Access Compliance Report

Public Rights-of-Way

(Curb Ramps)

Intersection ID: 30034	Main Street: DAY_LILLY_LN	Cross Street: SUMMER_COACH_DR	Location: W
ADA ID: 5A6548DFE2DF	Ramp Type: Perp	Initial Pass/Fail: Pass	Overall Compliance: No
Severity Score: 10			
Codes/Mitigation Info/Possible Solution		Field Measurements/Component Compliance

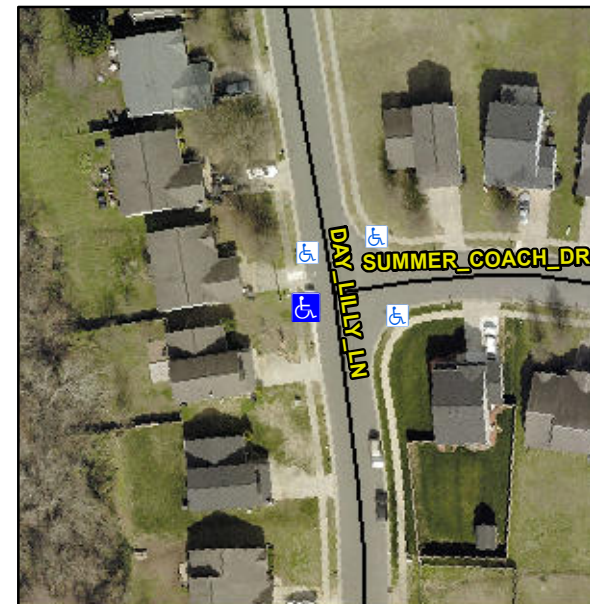
**R304.2.2-Perp, R304.3.2-Para,
R304.2.3, R305.2, R302.7.2**

**Remove & Replace Entire Ramp.
Grind Gutter Lip.**
